# Access Compliance Report

## Public Rights-of-Way

Intersection ID: 17902	Main Street: MONROE_RD	Cross Street: CONFERENCE_DR	Location: NE
ADA ID: 01DB54AAC446	Ramp Type: PerpDiag	Initial Pass/Fail: Fail	Overall Compliance: No
Severity Score: 37.5			
Codes/Mitigation Info/Possible Solution		Field Measurements/Component Compliance

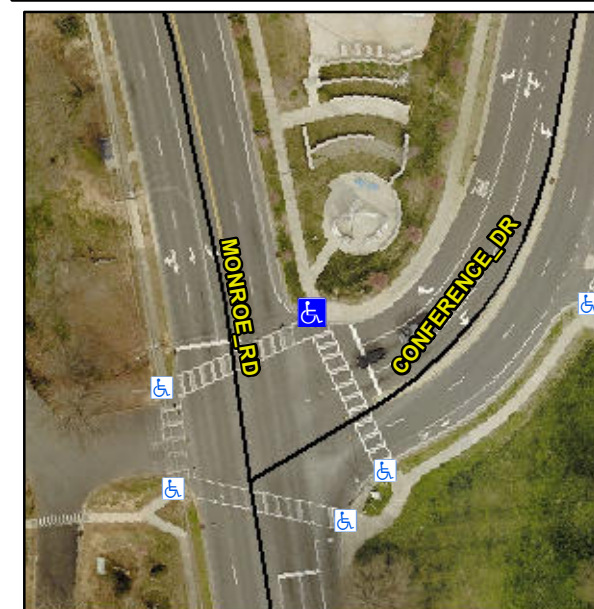
Compliance	Description	Data	Compliance	Description	Data
N/A	Ramp Length (in)	65.0	No	Ramp Slope (%)	9.8
Yes	Ramp Width (in)	57.0	No	Ramp XSlope (%)	7.2
N/A	Flare Type LT	N/A	N/A	Flare Type RT	N/A
N/A	Flare Slope LT (%)	N/A	N/A	Flare Slope RT (%)	N/A
N/A	Flare Traversable LT?	N/A	N/A	Flare Traversable RT?	N/A
N/A	Landing Length (in)	N/A	N/A	DWS Provided?	N/A
N/A	Landing Width (in)	N/A	N/A	DWS Contrast?	N/A
N/A	Landing Slope (%)	N/A	N/A	DWS Length (in)	N/A
N/A	Landing X Slope (%)	N/A	N/A	DWS Full Width?	N/A
N/A	Landing Curb? (Y/N)	N/A	N/A	DWS Offset (in)	N/A
N/A	Shared Landing?	N/A			
N/A	Gutter Ponding?	N/A	N/A	Gutter Slope (%)	N/A
N/A	Gutter Lip Ht (in)	N/A	N/A	Gutter X Slope (%)	N/A
N/A	Painted X Walk1?	Yes	N/A	Painted X Walk2?	Yes
	X Walk 1 Direction	To SW		X Walk 2 Direction	To SE
N/A	X Walk 1 Width (in)	111.0	N/A	X Walk 2 Width (in)	112.0
	X Walk 1 Slope (%)	3.3		X Walk 2 Slope (%)	3.0
	X Walk 1 X Slope (%)	2.5		X Walk 2 X Slope (%)	6.3

N/A	Ramp inside XWalk1?	Yes	N/A	Ramp inside XWalk2?	Yes
	Road Slope (%)	5.9	N/A	Clear Space?	N/A
	Road X Slope (%)	0.7	N/A	Clear Space to XWalk (in)	N/A
N/A	Any Obstructions?	N/A	N/A	Storm Grate/Utility Hazard?	N/A
	Obstruction Type			Storm Grate/Utility Type	
		N/A			N/A
		Yes		Surface Condition? (G/P)	Good

**Remove & Replace Curb Ramp With Two New Directional Ramps or Equivalent.**

**R304.2.2, R304.5.3**
